**SARA technical agency assessment response—pre-lodgement
Technical agency (TA) — Department of Environment and Science**

DSDMIP reference: 1907-12338 SPL
DSDMIP regional office: Fitzroy/Central regional office
DSDMIP email: RockhamptonSARA@dsdmip.qld.gov.au

Street address: Yeppoon Road, Yeppoon
Real property description: 3SP104438
Local government area: Livingstone Shire Council

Development description: Refer attached Project Planning Report

Figure 5 – Earthworks excavations and channel construction is not proposed to be progressed at this stage.

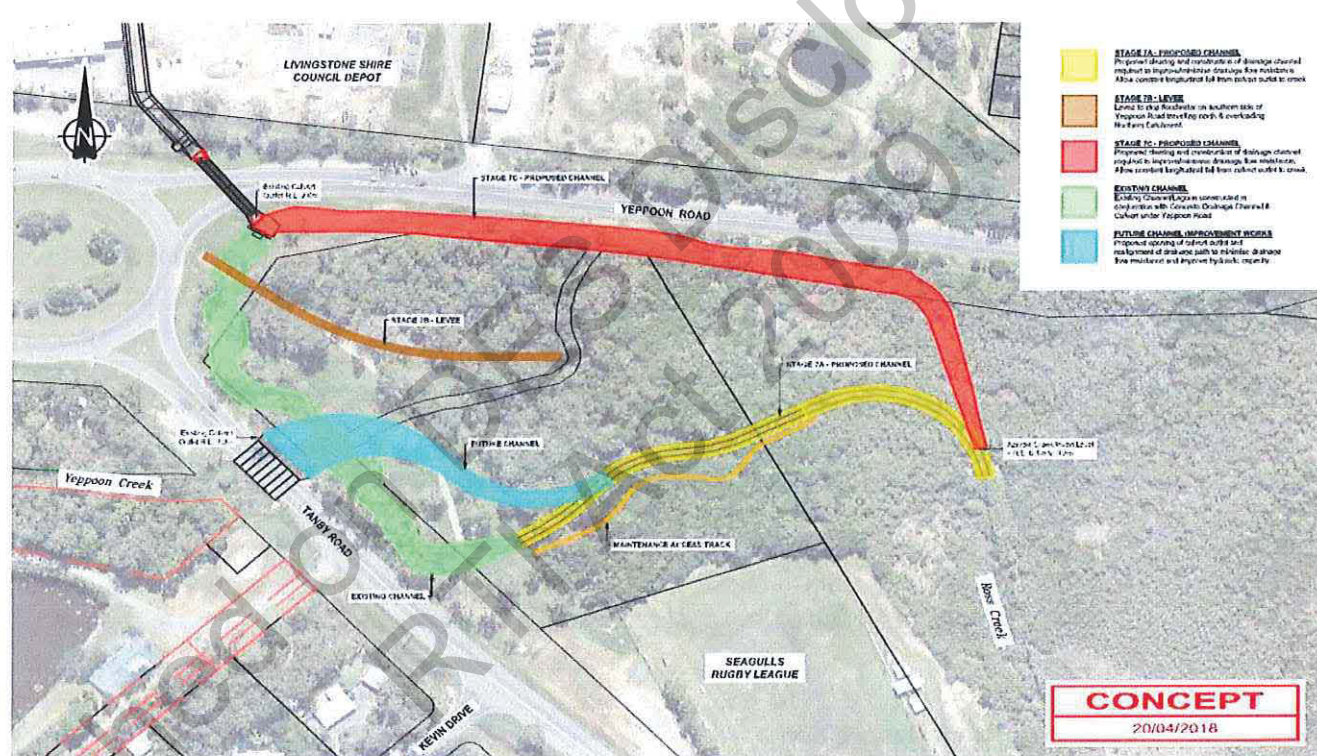
Stage 7A: (Highlight in Yellow) shows the proposed clearing, excavation and construction of a new unlined channel from the Tanby Rd culverts through the mangrove fringe, to an existing channel point in the mangroves. This earth channel is estimated to be 250m length (Figure 5). These works are considered assessable development pursuant to Schedule 10, Part 17, Division 1, Section 28 of the *Planning Regulation 2017* and would require a development approval under the aforementioned legislation. The reason for the development approval requirement is because the works are being undertaken within the CMD, Erosion Prone Area and Tidal Waters. The MSES essential habitat and regulated vegetation intersecting a watercourse are overlaid over the proposed works and need to be considered as part of any future application.

Stage 7B: (Highlight in Brown) shows Levee to be in place to stop floodwater on Southern side of Yeppoon Road travelling north and overloading Northern catchment. The constructed Levee bank between the Tanby Rd culvert and the Yeppoon Road is to be approximately 100m long, 1m high and will be constructed with a gentle batter (1:6) for mowing (Figure 5). These works are considered assessable development pursuant to Schedule 10, Part 17, Division 1, Section 28 of the *Planning Regulation 2017*

and would require a development approval under the aforementioned legislation. The reason for the development approval requirement is because the works are being undertaken within the CMD and the Erosion Prone Area. The MSES essential habitat and regulated vegetation intersecting a watercourse are overlaid over the proposed works and need to be considered as part of any future application.

Stage 7C: (Highlight in Red) shows the proposed clearing and construction of drainage channel required to improve/ minimise drainage flow resistance. This will be done by excavating a new unlined channel from the Yeppoon Road culvert, through the mangrove fringe, to a dispersion point in the mangroves. This earth channel is approximately 380m in length, with bed width of 3m, a depth of 2m, and a batter slope of 1:2 (Figure 5). These works are considered assessable development pursuant to Schedule 10, Part 17, Division 1, Section 28 of the *Planning Regulation 2017* and would require a development approval under the aforementioned legislation. The reason for the development approval requirement is because the works are being undertaken within the CMD, Erosion Prone Area and Tidal Waters. The MSES essential habitat and regulated vegetation intersecting a watercourse are overlaid over the proposed works and need to be considered as part of any future application.

3. With regard to the earthworks excavations and channel construction not proposed to be progressed at this stage -

Tidal works and works in a coastal management district are assessable development under Schedule 10, Part 17, Division 1, Section 28 of the Planning Regulation 2017 (Planning Regulation) and require a development approval before the works can be undertaken. Operational work that is tidal works or work in a coastal management is assessable development, if the work is:
